**Re: Monterey Bay Shores Ecoresort (“MBS”) Project
Appeal No. A-3-SNC-114 (Security National Guaranty (“SNG”)
Hearing Pursuant to Settlement Agreement**

This firm, with McCabe and Company, represents SNG in seeking your approval of the Monterey Bay Shores (“MBS”) Ecoresort Project, a 368-unit mixed-use resort development proposed on an oceanfront parcel in the City of Sand City on the Monterey Peninsula.

We have instead prepared the attached redline of Staff’s recommended conditions. Many conditions are acceptable, even though they differ from our Exhibit B to the Settlement Agreement. Those in dispute we have divided into two tiers. Tier 1 represents conditions that we ask be tweaked, and we believe this should be no problem for the Commission. Tier 2 are the conditions that are unacceptable to SNG, and which are addressed in this letter. At this point, after 15 years of running an administrative and litigation gauntlet, SNG understandably needs a Commission approval that achieves certainty (i.e., no further permits) and a Project that is economically feasible, buildable, operational, and financeable. If the conditions are

Exhibit 6 Dune View Line
A-3-SNC-98-114 Settlement Agreement
1 of 1

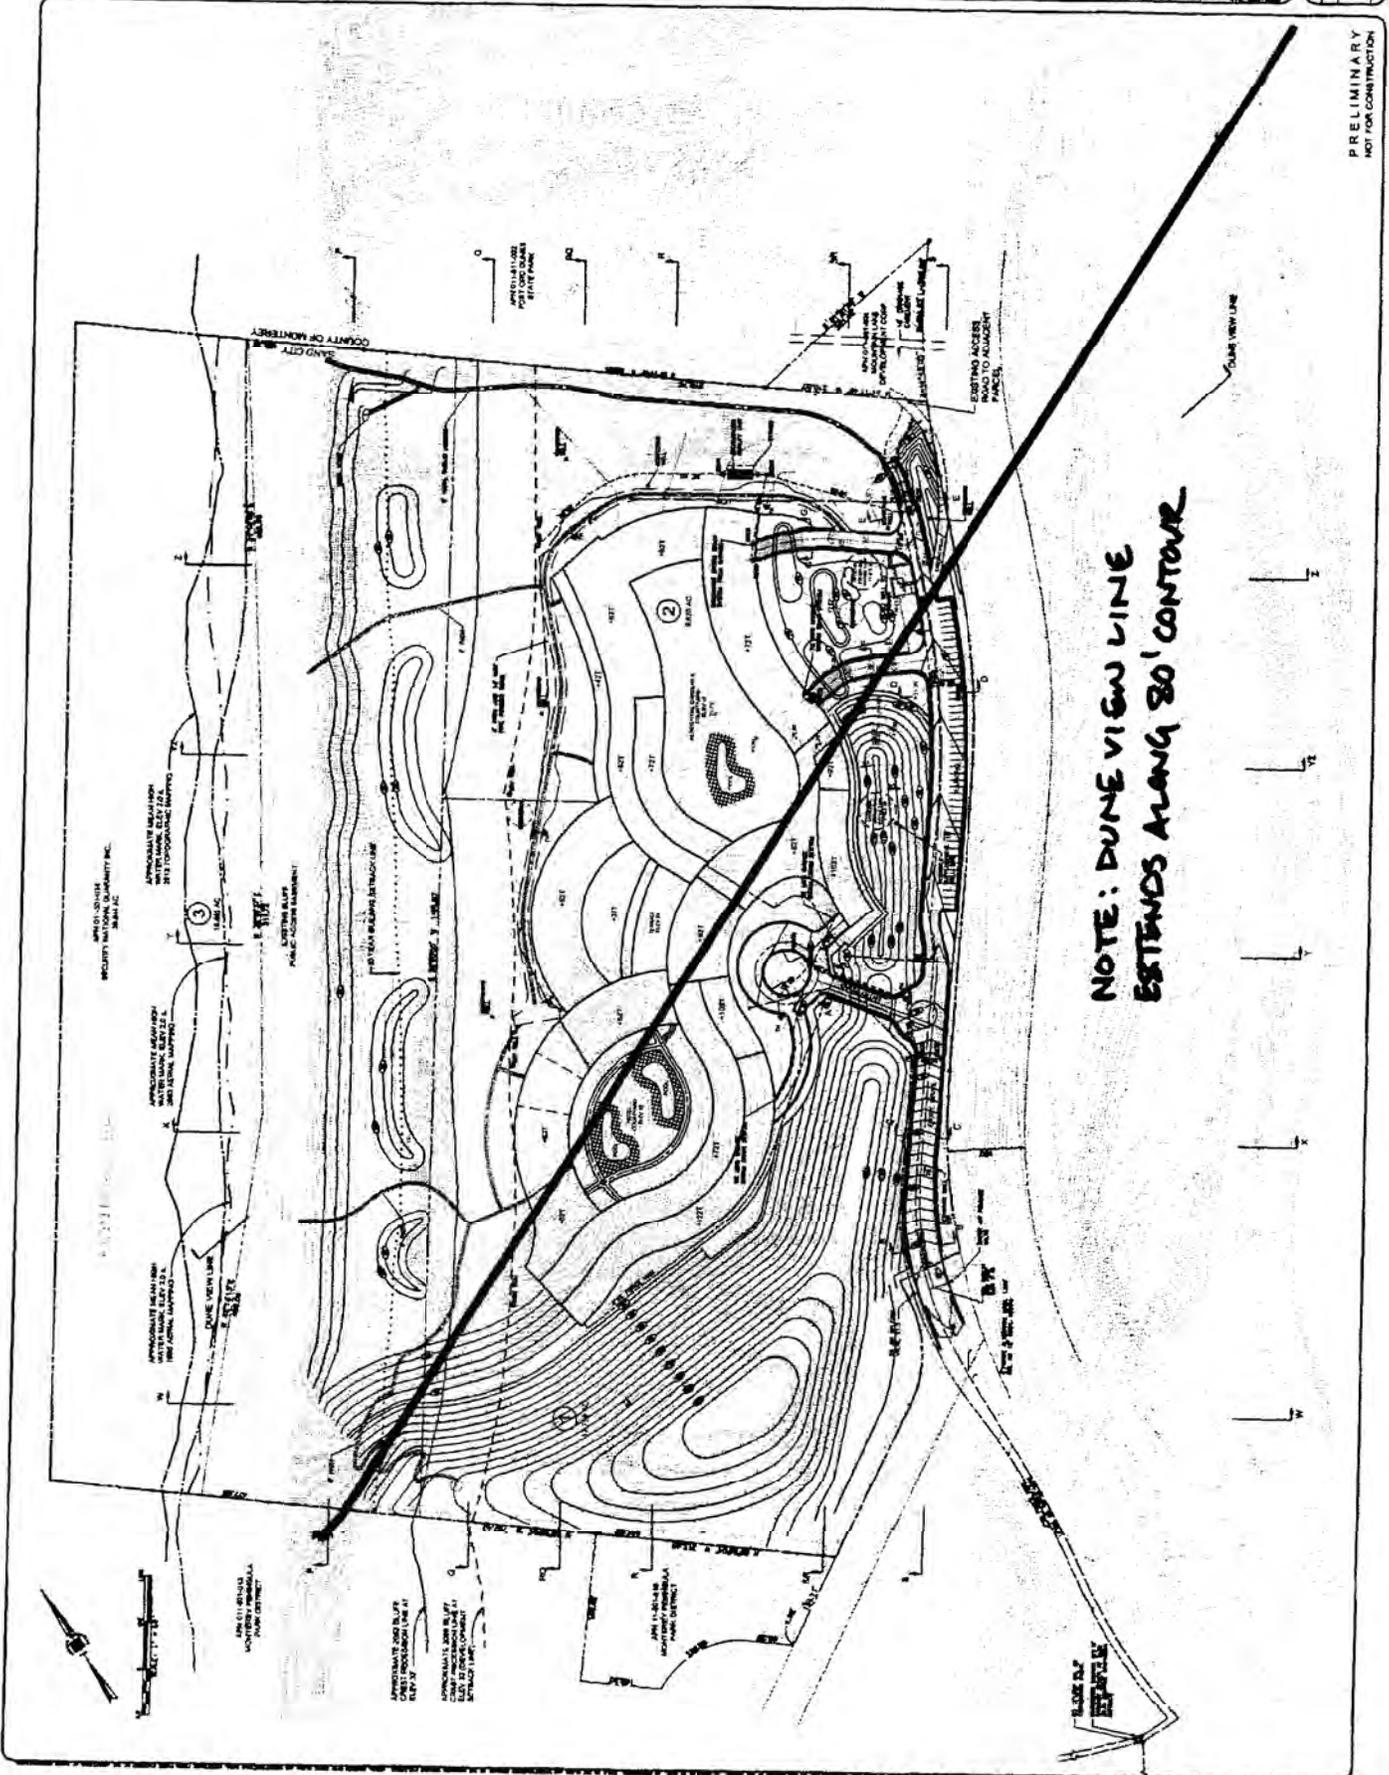
B. The Conceptual Site Plan’s “Dune View Line” Versus Staff’s New “Dune Line” -- Modify Staff’s Special Conditions 1, 1a-b

instead recommends, post-settlement, a different, extreme “Staff Dune Line” along the 80’ contour, essentially running from one end of the restored dune to the other. (See attached Exh. 2.)

Beyond that, there are three reasons why the “Staff’s Dune Line” makes no sense. First, a simple review of the topo on the Vesting Tentative Map (VTM) shows that this particular line currently provides no bluewater view at all. As viewed by a motorist from Highway One at approximately 81’ (5’ above the highway), the line runs first through a tall grove of Cypress trees (108’), then there is a modest-sized dune at 79’ westward, and finally a tall dune at 91’ is also located west of that line – all obstructing any water view. Second, as explained, the LCP does not require a “dune view line,” much less require creating yet additional bluewater views where none presently exist. The “Dune View Line” shown on the Conceptual Site Plan (V4.3) provides a more than generous view corridor in addition to the LCP-designated view corridor shown on Figure 9 in the LCP. Lastly, and critical for SNG, Staff’s new line would require lopping off portions of the middle of the resort Project, inconsistent with the Conceptual Site Plan and the specific building elevations on which the Commission agreed settlement would be based, thereby destroying the form of the Project proposed. By contrast, the “Dune View Line” on the Conceptual Site Plan (V4.3), previously reviewed by the Commission and to which SNG and Staff previously agreed in the Settlement Agreement, does preserve existing bluewater views.

SNG therefore requests that the Commission modify Staff's Special Conditions 1, 1a-b to make clear that "dune view line" is that shown on the "Conceptual Site Plan" (V4.3), not the line Staff created after settlement.

CCC Exhibit 266
 (page 1 of 1 pages)

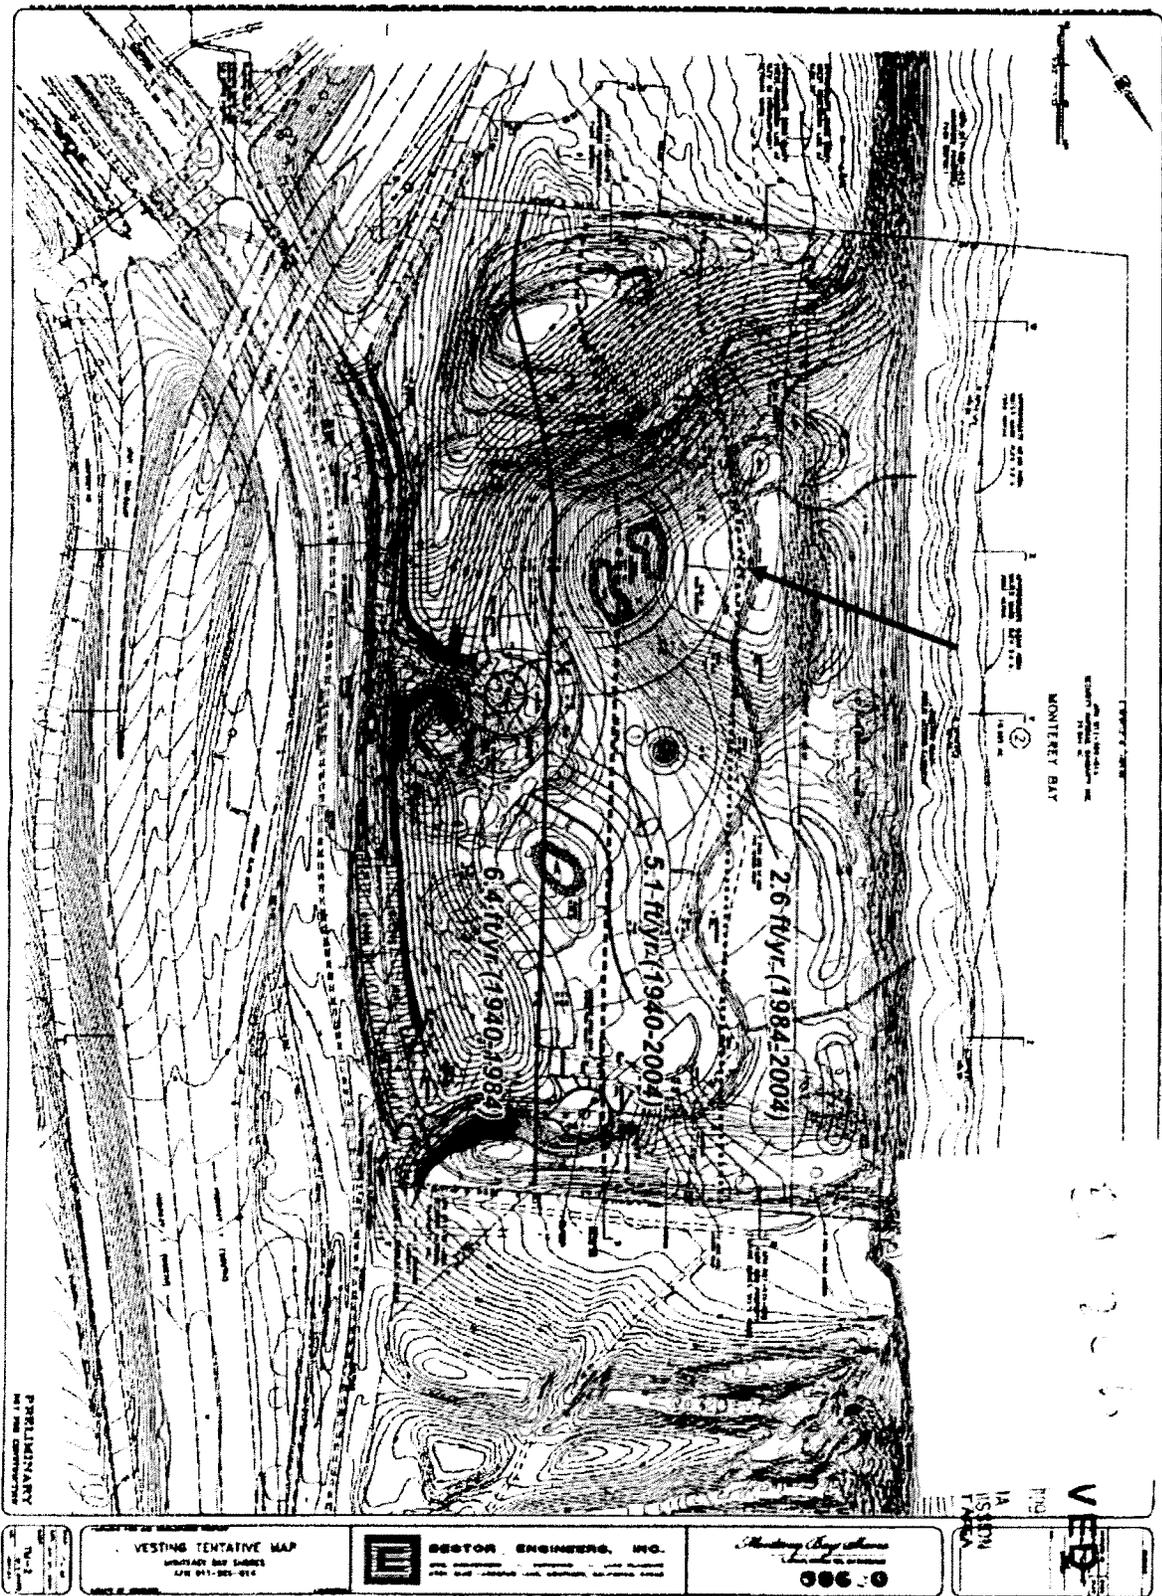
75 Year /2.6 Feet per Year Erosion Setback Line – Substitute Staff's Exhibit 20b to the 2009 Staff Report for Exhibit 9 to the Current Staff Report

(using the inland edge of the line)." (Emphasis added.) Staff's Exhibit 9 is a crude line drawn with a broad felt pen that compromises the Project. (See attached Exhibit 3.) By contrast, in 2009, when the Commission considered the Project on remand following the Court of Appeal decision in SNG I, Staff produced an exhibit (Exh. 20b) with a professionally drawn erosion setback line which, for purposes of the resort structure, is nearly coincidental with SNG's line on the VTML. (See attached Exhibit 4.) Both exhibits are attached to show the difference.

SNG requests for Exhibit 9 to the Staff Report, that the 2009 exhibit be substituted for the hand-drawn line if SNG is to agree to the 75 year/2.6 feet per year line.
